CALL NO. 411
CONTRACT ID NO. 213135
ADDENDUM # 1

Subject: Hancock County, 046GR21R069-CB06
Letting August 20, 2021

- (1) Revised - Special Note - Page 10 of 61
- (2) Added - Special Note - Pages 10a of 61
- (3) Revised - Material Summary - Page 35 of 61
- (4) Revised - Proposal Bid Items - Page 61 of 61

Construct Turnaround on Old KY 2181:

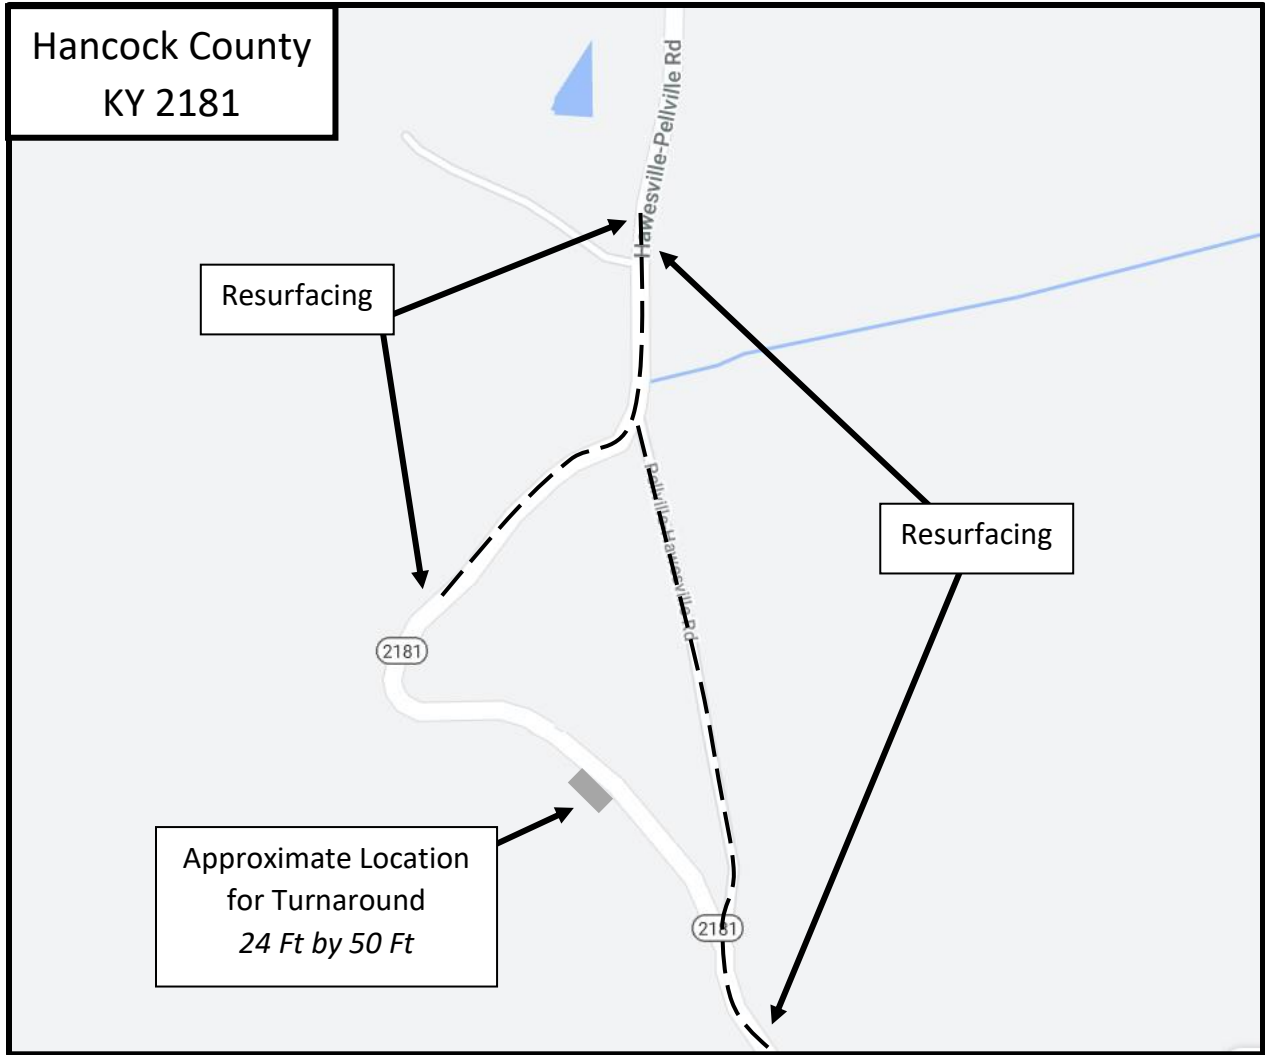
Construct at turnaround on old KY 2181. It will be approximately 24 foot wide and 50 foot long. The pavement structure will be 6 IN of DGA, 4.5 IN of Asphalt Base and 1 IN of Asphalt Surface. It will also require a 50 foot Longitudinal Edge Key to tie the Asphalt Base into the existing roadway. Approximately 45 Linear Feet of 15 IN culvert pipe will also be installed in the roadside ditch, to accommodate this widening. The area needs to be graded to drain. All grade work will be incidental to the DGA.
